S1C17 Family Technical Manual Errata

S1C17 Family Technical Manual Errata

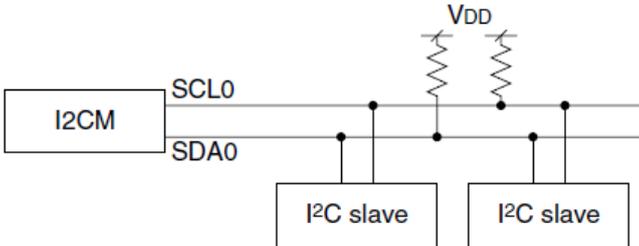
ITEM I2C Slave Input/Output Pins			
Object manual	Document code	Object item	Page
S1C17601 Technical Manual	411805701	21.2 I2C Slave Input/Output Pins	21-2
S1C17611 Technical Manual	411882301	21.2 I2C Slave Input/Output Pins	21-2
S1C17706 Technical Manual	412026401	18.2 I2CS Input/Output Pins	18-1
S1C17002 Technical Manual	411554402	V.3.2 I2C Slave I/O Pins	V-3-2
S1C17003 Technical Manual	411635102	21.2 I2C Slave Input/Output Pins	21-2
S1C17803 Technical Manual	411820401	21.2 I2CS Input/Output Pins	21-2
<p>(Addition)</p> <p>Note: The pins go to high impedance status when the port function is switched. The SCL and SDA pins do not output a high level, so these lines should be pulled up to VDD with an external pull-up resistor. Be sure to avoid pulling these pins up to a voltage that exceeds the VDD level.</p>  <p>The diagram illustrates an I2C bus configuration. On the left, a box labeled 'I2C master' is connected to two horizontal lines representing the SDA and SCL buses. Below these lines, two boxes represent the 'I2CS' and 'I2C slave' devices. The SDA1 pin of the I2CS and the SCL1 pin of the I2CS are connected to the SDA bus. The SCL1 pin of the I2CS and the SCL1 pin of the I2C slave are connected to the SCL bus. Two resistors are shown connected between the SDA and SCL buses and a common VDD supply line, representing pull-up resistors. The VDD supply line is indicated by a vertical line with a zigzag resistor symbol.</p>

P26-1(S1C17711)

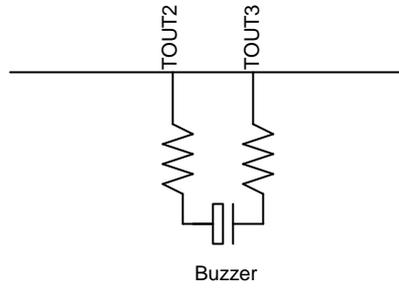
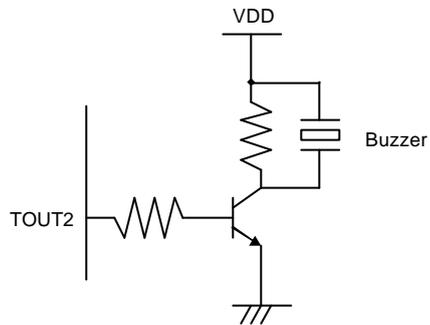
ITEM: Basic External Connection Diagram		
Object manuals	Document code	Object number
S1C17705	411706600	P26-1
S1C17711	411905600	P26-1
S1C17121	411723700	P29-1
S1C17601	411805700	P29-1
S1C17611	411882300	P29-1
S1C17621/602/622/604/624	411914900	P30-1
P26-1(S1C17705)		
<p>(Error)</p> <div style="text-align: center; margin: 10px 0;"> </div>		
<p>(Correct)</p> <div style="text-align: center; margin: 10px 0;"> </div>

(Error)

(Correct)

P30-1(S1C17621/602/622/604/624)

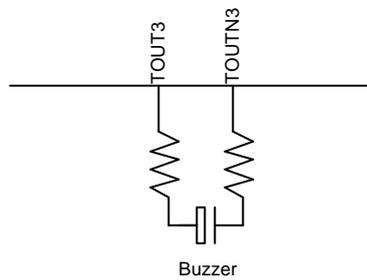
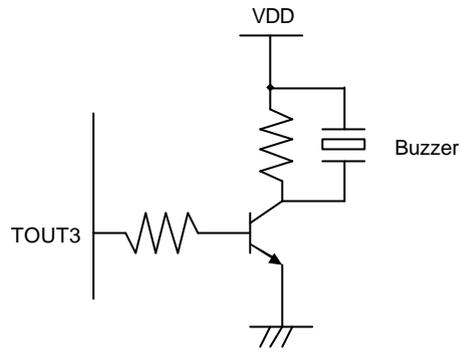
P29-1(S1C17121, S1C17601, S1C17611)

(Error)

(Correct)

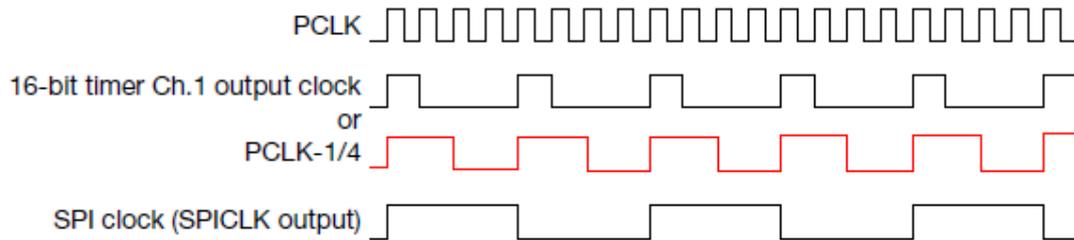
ITEM: SPI Clock		
Object manuals	Document code	Object number
S1C17121	411723700	P19-3
S1C17702	411581700	P19-3
S1C17003	411635100	P19-3
S1C17601	411805700	P19-3
S1C17611	411882300	P19-3
S1C17705	411706600	P15-2
S1C17621/S1C17602/S1C17622/ S1C17604/S1C17624	411914900	P19-3
P19-3(S1C17602,S1C17121,S1C17702,S1C17003,S1C17601,S1C17611)		
<p>(Error)</p> <p>The Master mode SPI uses the internal clock output by the 16-bit timer Ch.1 as SPI clock. This clock is output from the SPICLK pin to slave device while also driving the shift register. Use the MCLK(D9/SPI_CTL register) to select to use the 16-bit timer ch.1 output clock or PCLK-1/4 clock. Setting MCLK to 1 selects the 16-bit timer Ch.1 output clock; setting to 0 selects to 0 selects the PCLK-1/4 clock.</p> <p>*MCLK: SPI Clock Source Select Bit in the SPI Control(SPI_CTL)Register(D9/0x4326)</p> <p>Using the 16-bit timer Ch.1 output clock enables programmable transfer rates. For more information on 16-bit timer control, see "11 16-bit Timer(T16)."</p> <p>The diagram shows three digital signals over time. The top signal, labeled 'PCLK', is a high-frequency square wave. The middle signal, labeled '16-bit timer Ch.1 output clock or PCLK-1/4', is a square wave with a frequency approximately one-fourth that of PCLK. The bottom signal, labeled 'SPI clock (SPICLK output)', is a square wave with a frequency approximately one-fourth that of the middle signal.</p>

(Correct)

The Master mode SPI uses the internal clock output by the 16-bit timer Ch.1 as SPI clock. This clock is output from the SPICLK pin to slave device while also driving the shift register. Use the MCLK(D9/SPI_CTL register) to select to use the 16-bit timer ch.1 output clock or PCLK-1/4 clock **is used**. Setting MCLK to 1 selects the 16-bit timer Ch.1 output clock; setting to 0 selects the PCLK-1/4 clock.

*MCLK: SPI Clock Source Select Bit in the SPI Control(SPI_CTL)Register(D9/0x4326)

Figure 15.3.1 Master Mode SPI Clock

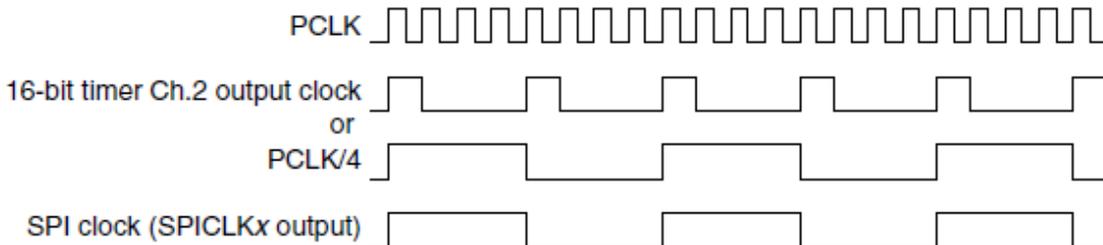
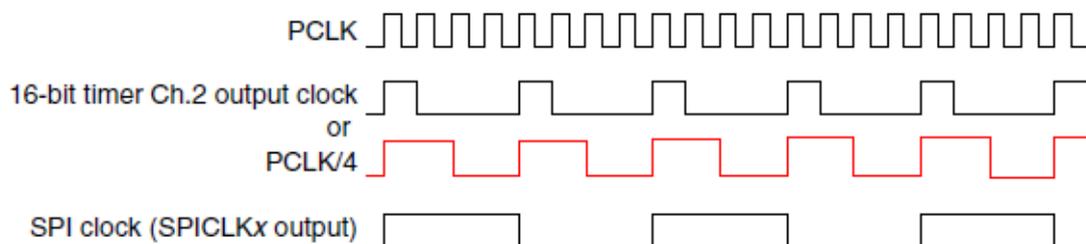
P15-2(S1C17705)

(Error)

(Correct)

Figure 19.3.1 Master Mode SPI Clock

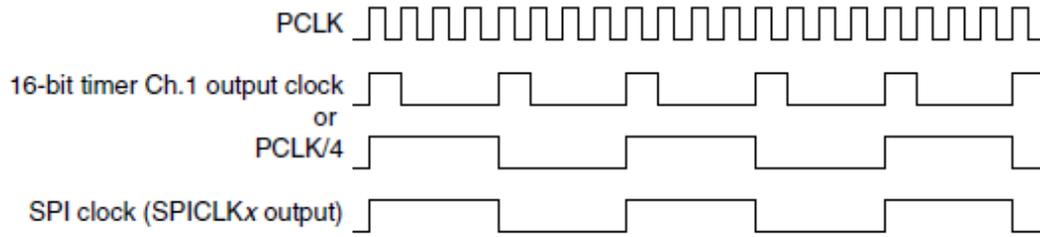
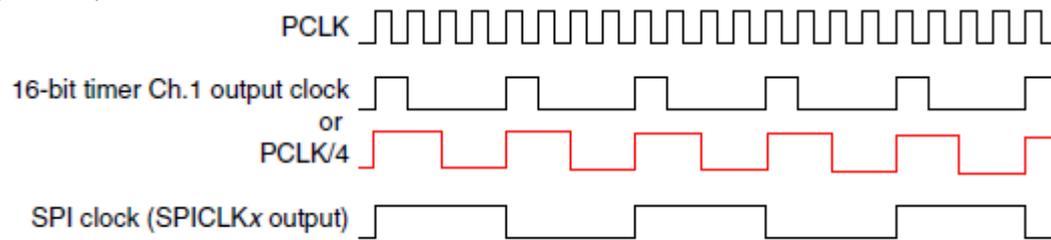
P19-3(S1C17621/S1C17602/S1C17622/S1C17604/S1C17624)

(Error)

(Correct)
